**PLANNING COMMISSION
STAFF REPORT**

RE: Preliminary Plat & Major Site Plan – 461 Muse Drive
To: Town of Fraser Planning Commission
From: Julie Esterl, Baseline
Project Number: TF-22-11
Project Address: 461 Muse Drive, Fraser
Applicant: Michael Ziehler, KBZ Investments LLC
Property Owner: Michael Ziehler, KBZ Investments LLC
Zoning: Low Density Multi-Family (LDMF) Residential District
CC: Ed Cannon, Fraser Town Manager
Ben Thurston, AICP, Baseline

PROPOSED SITE PLAN

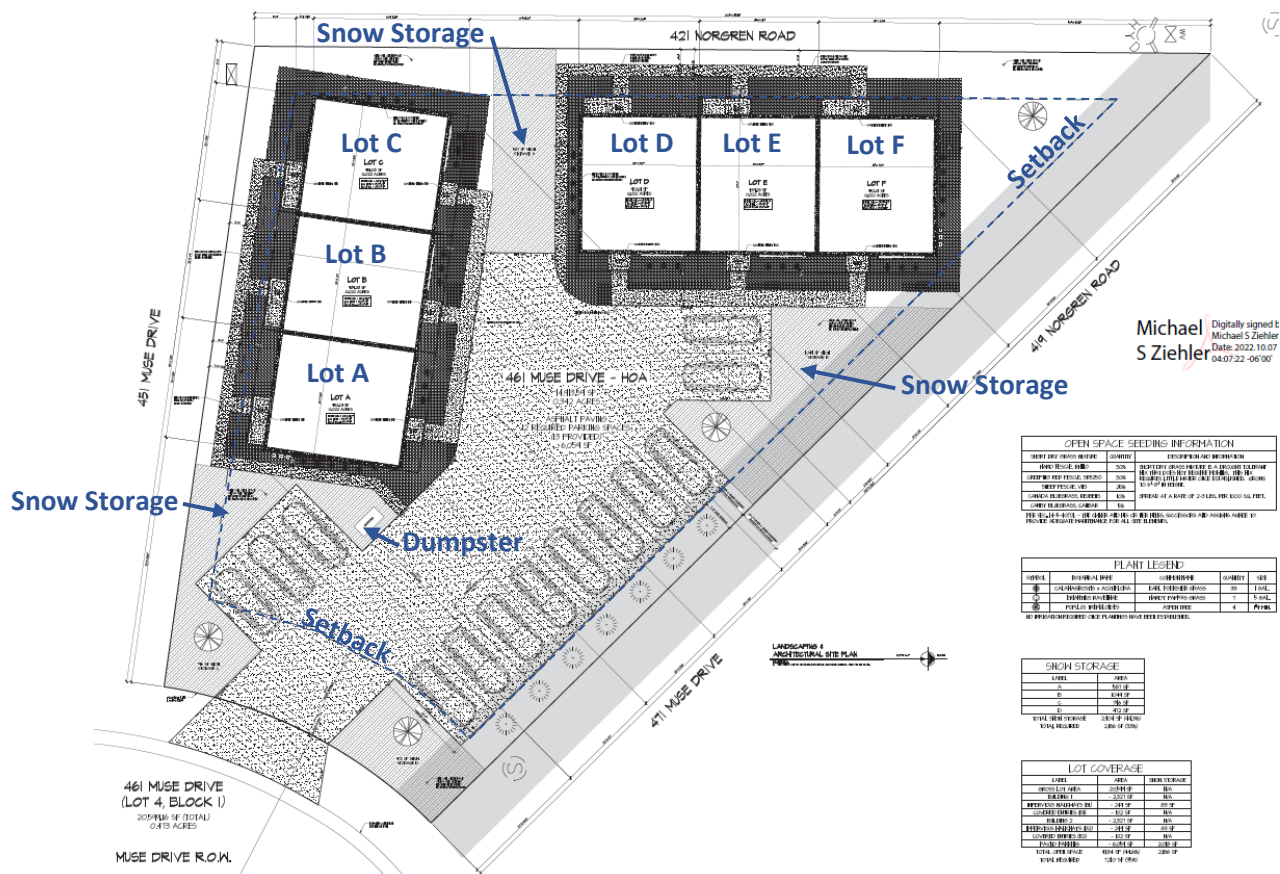
Parking requirements for residential uses are outlined in Section 19-4-230 and Table 4.1. Multi-family units with three bedrooms require two parking spaces per unit. For six units, a total of twelve parking spaces are required. One of the spaces must be an ADA van accessible designated space. The site plan provides thirteen parking spaces which meets the requirement; however, no accessible space has been designated. The designation of a van accessible parking space has been listed as a condition of approval.

Landscaping and screening are regulated by Section 19-4-160. All trash and storage areas must be screened from public view. The addition of an enclosure or landscaping to screen the proposed trash dumpster has been listed as a condition of approval.

- Revegetation with a native seed mix has been included as required for all disturbed areas.
- Parking lot landscape requirements: One tree and 2 shrubs are required for every twenty feet of parking lot frontage. Sixty-four feet of frontage requires 4 trees and 8 shrubs. Four trees have been provided, but only seven shrubs have been provided. The addition of one shrub is listed as a condition of approval.

Snow storage is regulated by Section 19-4-185 and requires that areas be reserved for snow storage in the amount of 33% of the paved areas. The paved parking area includes 6,059 square feet. 2,904 square feet have been designated as snow storage areas which is 47.9% of the paved areas. The land use tables on Sheet A2 show some discrepancies in these calculations which need correction and clarification. Updating the snow storage and lot coverage tables is listed as a condition of approval.

1. Applicant must address Planning comments and redlines dated October 26, 2022 including:
 - a) Designation of an ADA van accessible parking space
 - b) Screening of the dumpster

- c) Addition of one shrub
 - d) Clarification of the land use table
2. Applicant must address Referral Agency comments from:
 - a) Town of Fraser Water/Wastewater - dated November 3, 2022
